| VEHICLE MODEL | : CX45, TX45, TD925US, TDX25US |
| BULLETIN TYPE | : Product Improvement |
| DATE | : January 16 th , 2018 |
| SUBJECT | : Introduction of new transmission oil filler pipe assembly |

Figure 1

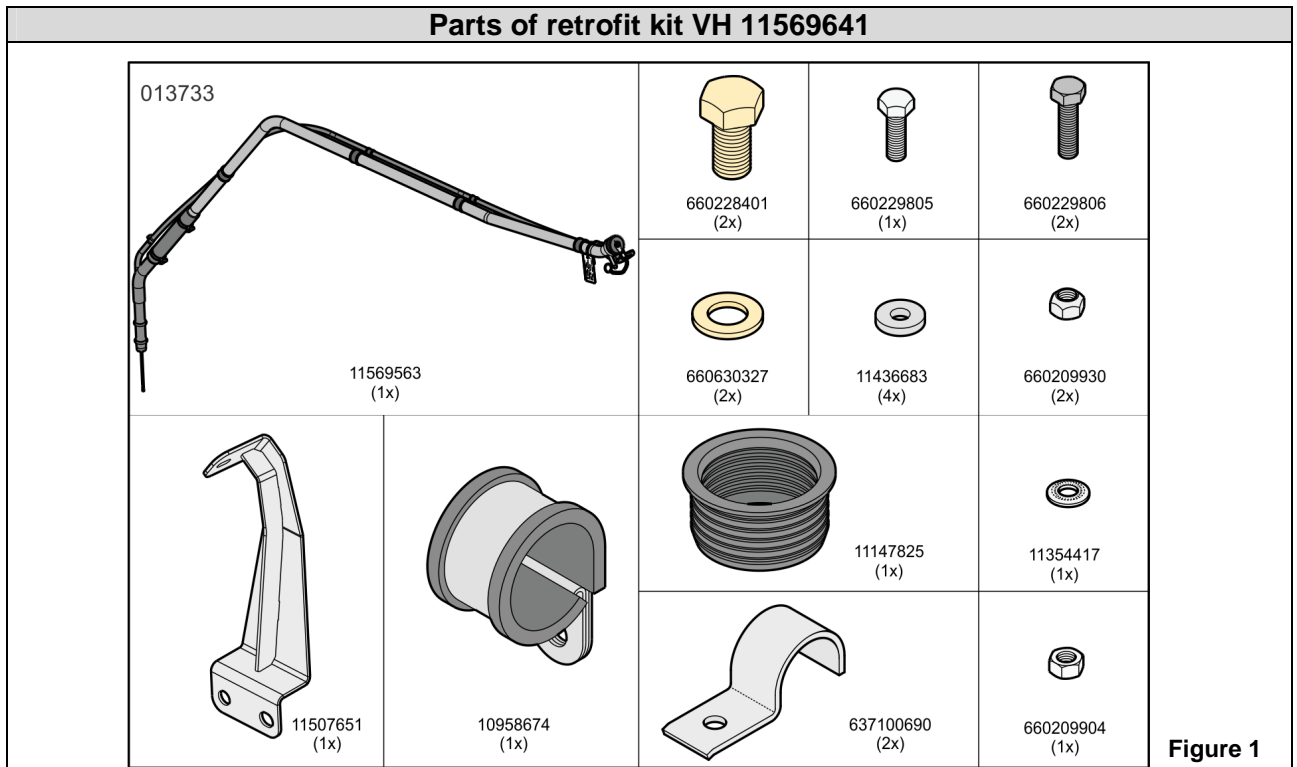
- The new oil filler pipe removes possible stress on the grommet (part #11147825) that seals the oil filler pipe assembly to the transmission housing due to vibrations of the oil filler pipe assembly. The grommet prevents moisture and foreign material from entering the transmission housing and, in this way contaminating the transmission fluid.
- New parts are supplied as a kit. This service bulletin gives step-by-step instructions to install the improved oil filler pipe assembly.
- This product improvement bulletin is applicable to previous units with Cummins ISX engine and Allison WTB500(R) transmission:

| CX45 and TX45 | 11569641 |

Figure 2

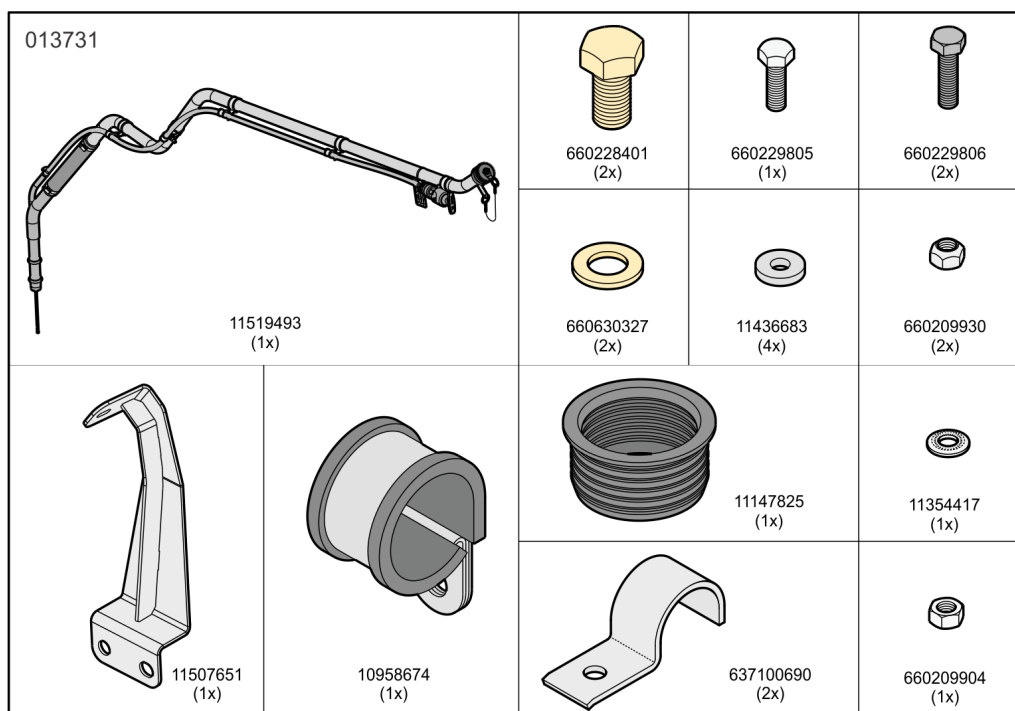
Parts of retrofit kit for VH 11569639

| TD925 and TDX25 | 11569639 |
